Figure 2.12a
Infrastructure Design Review
- Turbine 01

Tangy IV Wind Farm
S36C EIA Report 2026
Proposed Varied Development

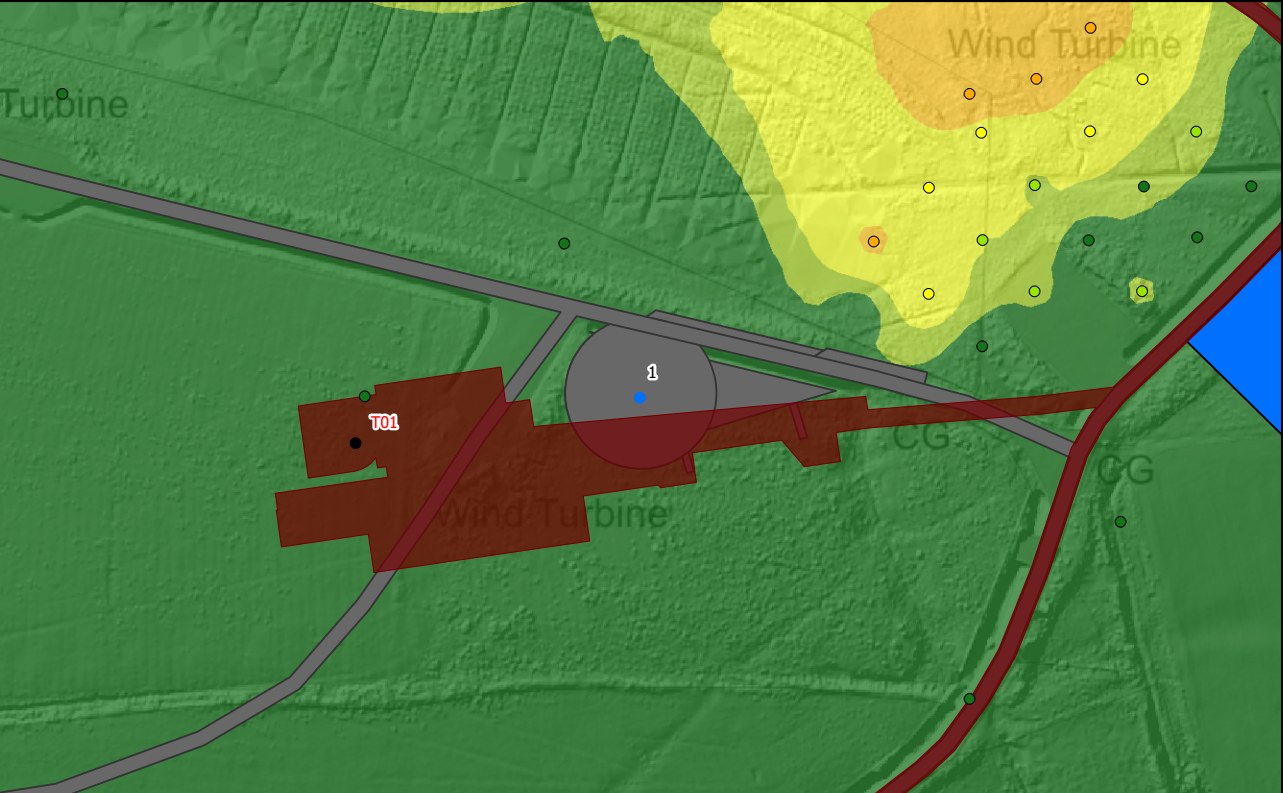
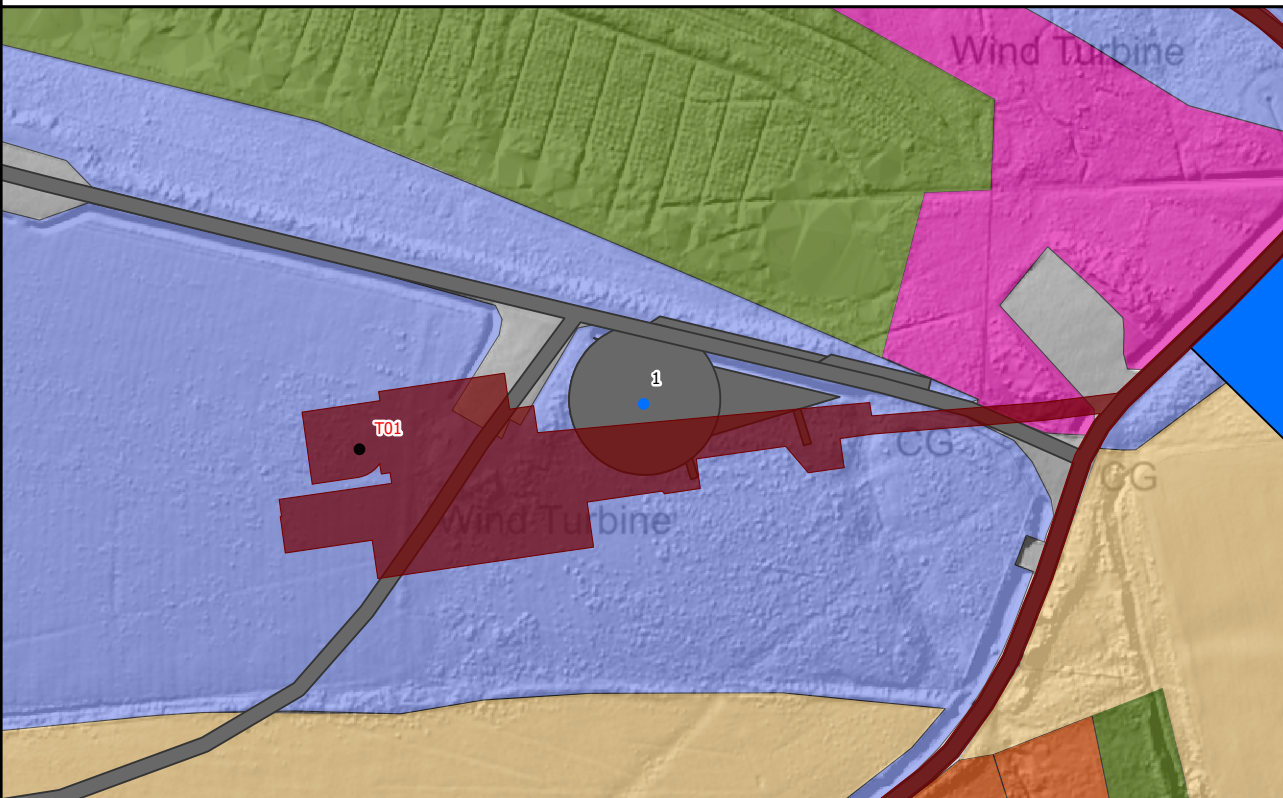
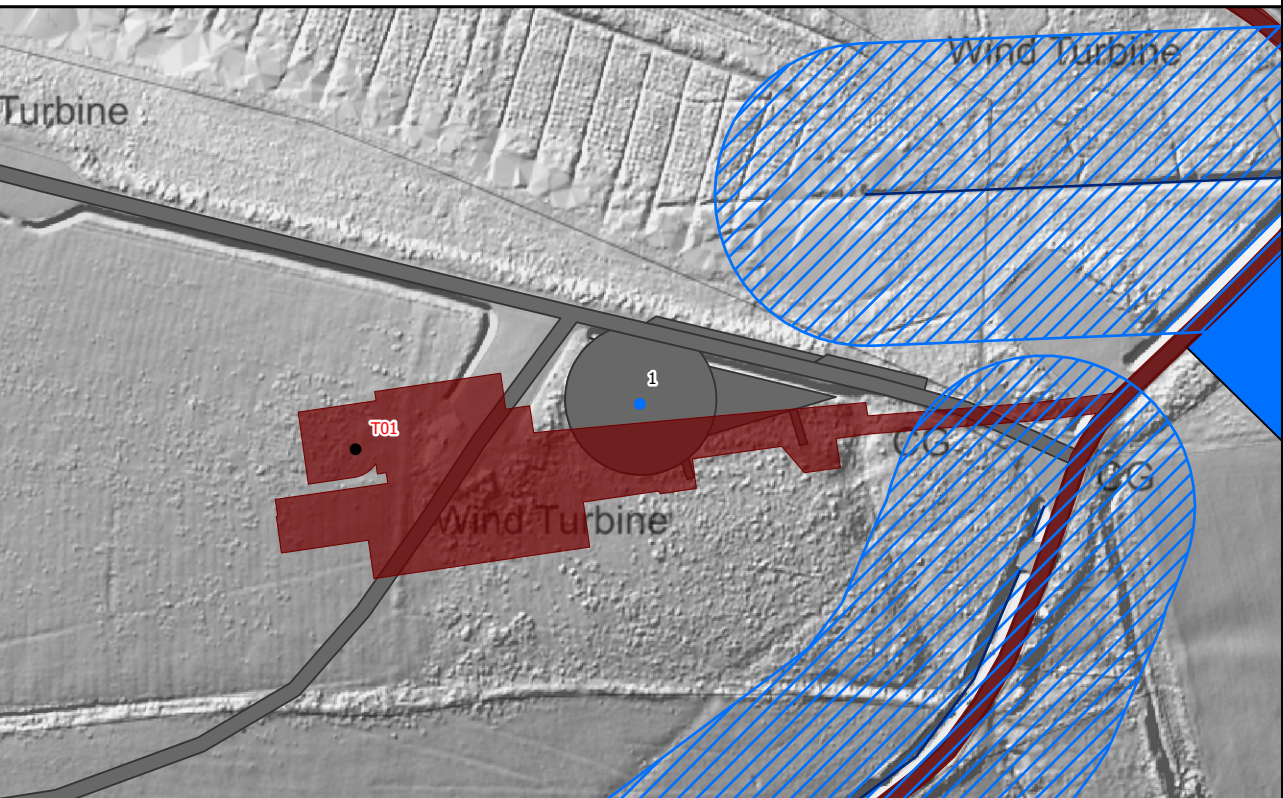
T01: Reason for Moving: The move was necessary to ensure that suitable separation distances were maintained between turbines. Where possible a minimum of three times the rotor diameter is required between turbines. T01 is positioned at this minimum distance from T03, maximising distance from neighbouring properties to the west (approximately 1km).

Engineering: The orientation of the hardstand has been positioned as such to follow the contours of the land to reduce the required cut and fill during construction. The entry to the spur aligns with the current water course crossing from Tangy I/II. This crossing will need to be upgraded as part of the new development. The plan for turbine component deliveries is to reverse loaded delivery vehicles in to the spur for T02 and then enter the spur for T01 in a forward direction. The distance from T01 to the main spine road is short enough to allow for delivery vehicle to reverse off the hard stand and exit the site without the need for a additional dedicated turning head.

Geology Impacts: The larger hardstand required the platform to be rotated clockwise. All proposed infrastructure within current consented 50m micro-siting buffers. All proposed infrastructure in similar shallow peat depths.

Ecology Impacts: The new location for the infrastructure sits within the same NVC areas as the consented development. The infrastructure will be located in predominantly M23, Mire with the spur crossing existing wind farm track and some M20 Mire.

Hydrology Impacts: The platform and the ancillary features are positioned outside of the 50m water course and private water supply buffers. The infrastructure within the water course buffer builds on existing track and water course crossings that are used on the operational Tangy I/II windfarm.
